Access Compliance Report

Public Rights-of-Way

Intersection ID: 21073	Main Street: COLONY_RD	Cross Street: SHARON_VIEW_RD	Location: SW
ADA ID: EAEF0C467F61	Ramp Type: PerpDiag	Initial Pass/Fail: Fail	Overall Compliance: No
		Severity Score: 22.5

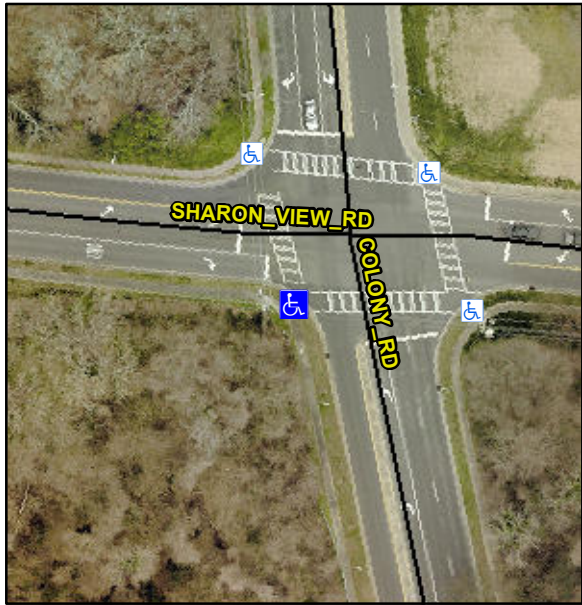
Codes/Mitigation Info/Possible Solution			Field Measurements/Component Compliance					
	Possible Solutions:		Compliance	Description	Data	Compliance	Description	Data
	Remove & Replace Curb Ramp With Two New Directional Ramps or Equivalent.		N/A	Ramp Length (in)	82.0	No	Ramp Slope (%)	9.0
			No	Ramp Width (in)	43.0	Yes	Ramp XSlope (%)	3.8
			N/A	Flare Type LT	N/A	N/A	Flare Type RT	N/A
			N/A	Flare Slope LT (%)	N/A	N/A	Flare Slope RT (%)	N/A
			N/A	Flare Traversable LT?	N/A	N/A	Flare Traversable RT?	N/A
			N/A	Landing Length (in)	N/A	N/A	DWS Provided?	N/A
			N/A	Landing Width (in)	N/A	N/A	DWS Contrast?	N/A
			N/A	Landing Slope (%)	N/A	N/A	DWS Length (in)	N/A
			N/A	Landing X Slope (%)	N/A	N/A	DWS Full Width?	N/A
<p>Surveyor Notes:</p> <p>N/A</p> <p>PROW/ADA:</p> <p>Not Found, R304.5.1, R304.2.2</p>			N/A	Landing Curb? (Y/N)	N/A	N/A	DWS Offset (in)	N/A
			N/A	Shared Landing?	N/A			
			N/A	Gutter Ponding?	N/A	N/A	Gutter Slope (%)	N/A

N/A	Gutter Lip Ht (in)	N/A	N/A	Gutter X Slope (%)	N/A
			N/A	Painted X Walk1?	Yes	N/A	Painted X Walk2?	Yes
				X Walk 1 Direction	To SE		X Walk 2 Direction	To N
			N/A	X Walk 1 Width (in)	106.0	N/A	X Walk 2 Width (in)	103.0
				X Walk 1 Slope (%)	4.8		X Walk 2 Slope (%)	5.4
				X Walk 1 X Slope (%)	0.7		X Walk 2 X Slope (%)	0.5
			N/A	Ramp inside XWalk1?	Yes	N/A	Ramp inside XWalk2?	Yes
			Road Slope (%)	5.8	N/A	Clear Space?	N/A	
			Road X Slope (%)	5.3	N/A	Clear Space to XWalk (in)	N/A	
		N/A	Any Obstructions?	N/A	N/A	Storm Grate/Utility Hazard?	N/A	
			Obstruction Type			Storm Grate/Utility Type		
					N/A		N/A	
						Yes	Surface Condition? (G/P)	Good
Total Cost:		\$ 3200.00
